United States Agency for International Development
Office of Economic Growth and Infrastructure
Afghanistan Engineering Support Program

Site Visit Report	Project: **Construction of Parking Lot and Park Improvement**
Location: **Taloqan City, Takhar Province**	**Coordinates:** **Latitude: N 6°44'10.356" Longitude: E °32'29.988"**
Inspection Date: **November 16, 2013**	Weather: **Sunny, Temp @ 19°C, No Precipitation**
[redacted]	Status: **Complete**

Work Order WO-LT-0009 AMD #5

Figure 7. View of the improper installation of PVC conduit

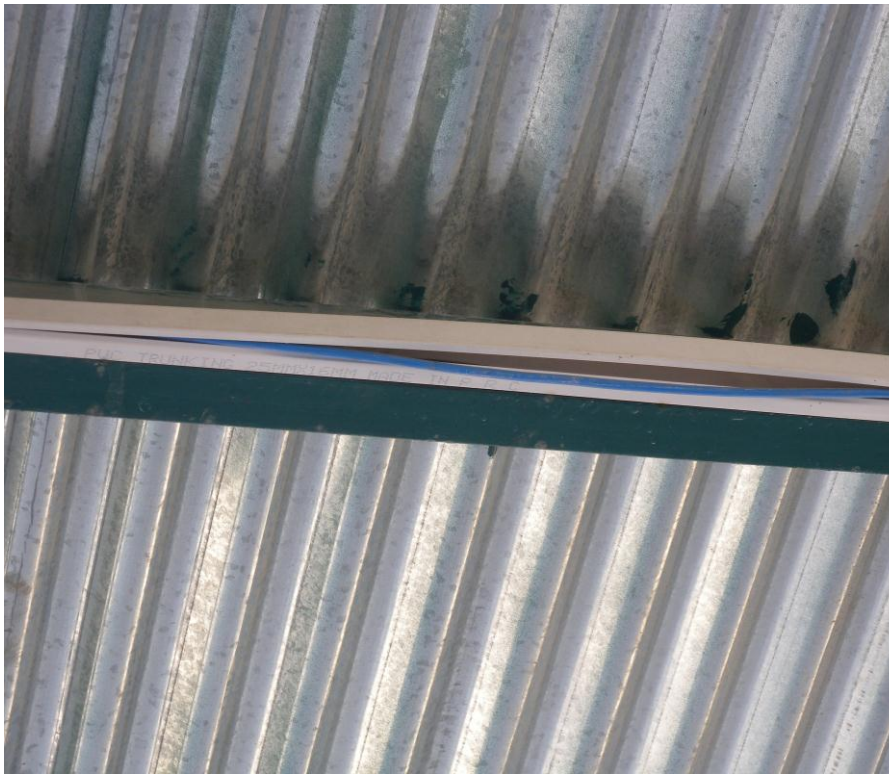
a. **Deficiency:** Some electrical wires are visible due to poor installation of Polyvinyl Chloride (PVC) conduit. (See Figures 6 and 7)
3. Construction of stone masonry boundary wall and installation of 506 linear meters of fence is complete. (See Figures 8 and 10)
